# Access Compliance Report

## Public Rights-of-Way

Intersection ID: 13007	Main Street: HAWTHORNE_LN	Cross Street: CENTRAL_AV	Location: SW
ADA ID: 49A3F3F33515	Ramp Type: PerpDiag	Initial Pass/Fail: Fail	Overall Compliance: No
Severity Score: 22.5			
Codes/Mitigation Info/Possible Solution		Field Measurements/Component Compliance

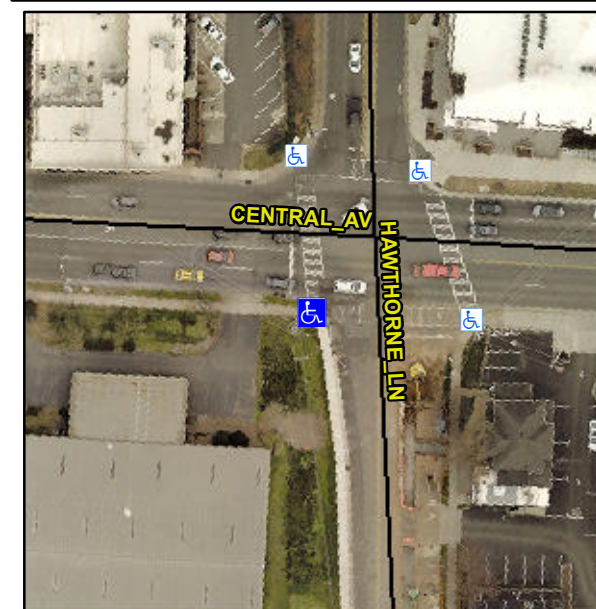
**Not Found, R304.5.1, R304.2.2, R304.5.3**

Compliance	Description	Data	Compliance	Description	Data
N/A	Ramp Length (in)	63.0	No	Ramp Slope (%)	10.0
No	Ramp Width (in)	46.0	No	Ramp XSlope (%)	3.5
N/A	Flare Type LT	N/A	N/A	Flare Type RT	N/A
N/A	Flare Slope LT (%)	N/A	N/A	Flare Slope RT (%)	N/A
N/A	Flare Traversable LT?	N/A	N/A	Flare Traversable RT?	N/A
N/A	Landing Length (in)	N/A	N/A	DWS Provided?	N/A
N/A	Landing Width (in)	N/A	N/A	DWS Contrast?	N/A
N/A	Landing Slope (%)	N/A	N/A	DWS Length (in)	N/A
N/A	Landing X Slope (%)	N/A	N/A	DWS Full Width?	N/A
N/A	Landing Curb? (Y/N)	N/A	N/A	DWS Offset (in)	N/A
N/A	Shared Landing?	N/A			
N/A	Gutter Ponding?	N/A	N/A	Gutter Slope (%)	N/A
N/A	Gutter Lip Ht (in)	N/A	N/A	Gutter X Slope (%)	N/A
N/A	Painted X Walk1?	Yes	N/A	Painted X Walk2?	Yes
	X Walk 1 Direction	To E		X Walk 2 Direction	To N
N/A	X Walk 1 Width (in)	105.0	N/A	X Walk 2 Width (in)	102.0
	X Walk 1 Slope (%)	0.2		X Walk 2 Slope (%)	6.3
	X Walk 1 X Slope (%)	2.7		X Walk 2 X Slope (%)	1.8

N/A	Ramp inside XWalk1?	Yes	N/A	Ramp inside XWalk2?	Yes
	Road Slope (%)	3.2	N/A	Clear Space?	N/A
	Road X Slope (%)	1.3	N/A	Clear Space to XWalk (in)	N/A
N/A	Any Obstructions?	N/A	N/A	Storm Grate/Utility Hazard?	N/A
	Obstruction Type			Storm Grate/Utility Type	
		N/A			N/A
		Yes		Surface Condition? (G/P)	Good

**Remove & Replace Curb Ramp With Two New Directional Ramps or Equivalent.**
